SUBJECT: NuScale Power, LLC Supplemental Response to NRC Request for Additional Information No. 201 (eRAI No. 8975) on the NuScale Design Certification Application

NuScale Supplemental Response to NRC Request for Additional Information eRAI No. 8975

eRAI No.: 8975

NRC Question No.: 03.08.04-26

Figure 3B-15: RXB Reinforcement Elevation at Grid Line 4 Wall

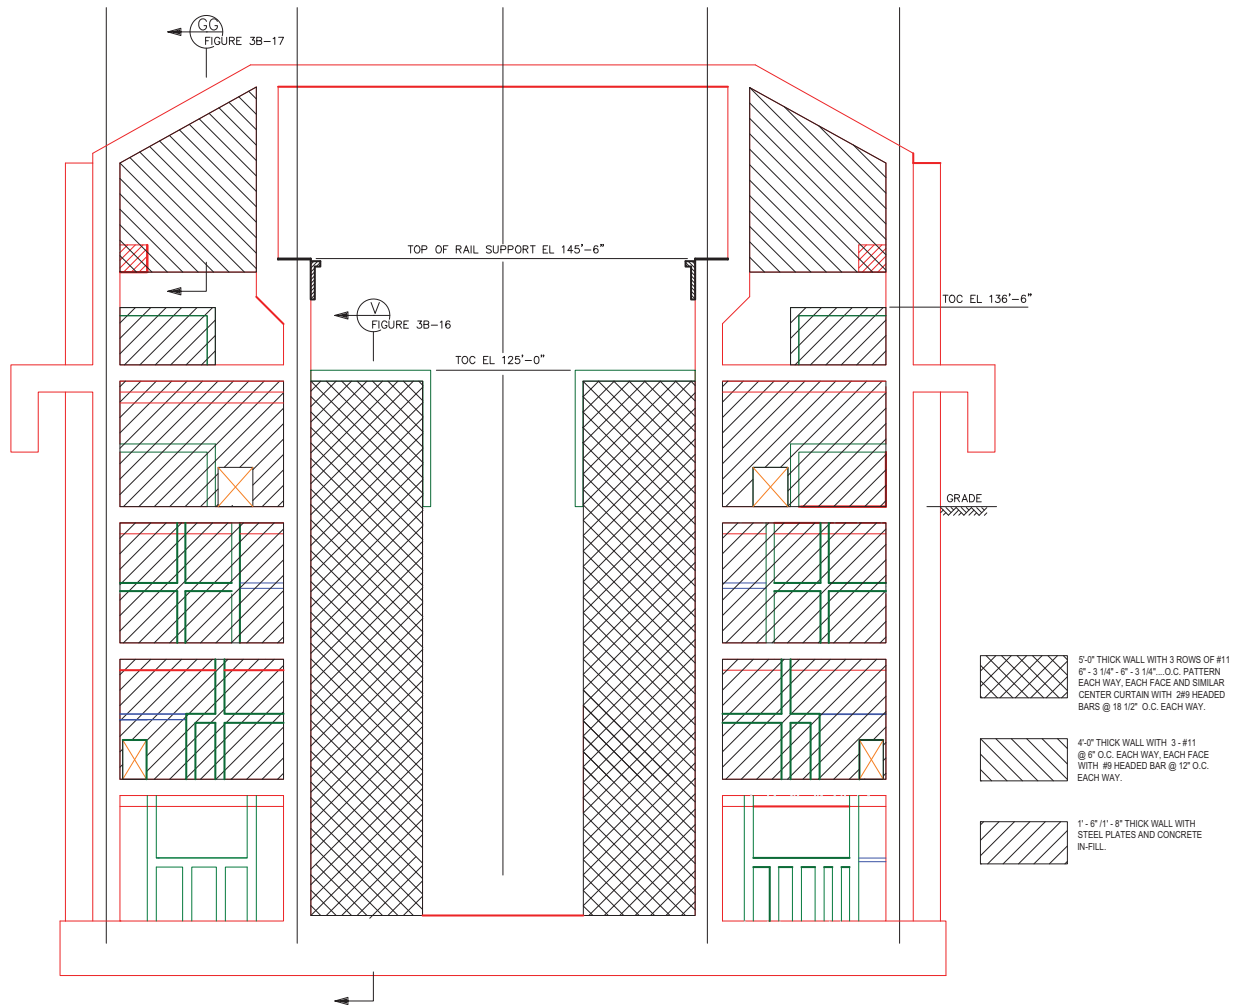
FSAR Tier 2, Appendix 3B, 3B.1.1.1, 3B.1.1.2 & 3B.2.7.1, and FSAR Tier 2, Tables 3B-4, 3B-5, 3B-6, 3B-9, 3B-12, 3B-22, 3B-45, 3B-55 & 3B-66 through 3B-94, and FSAR Tier 2, Figures 3B-15 & 3B-16 have been revised as described in the response above and as shown in the markup provided in this response.

Reinforcement drawings and section details are presented in ~~Figure 3B-43 and Figure 3B-44~~ [Figure 3B-15 and Figure 3B-16.](#)

| Structure Type | Location | Figure Reference | Critical Dimension* |
|-------------------|--|---|---------------------|
| NPM Bay | West wing wall | 3B-43, 3B-44 <u>3B-15, 3B-16</u> | 5'-0" |
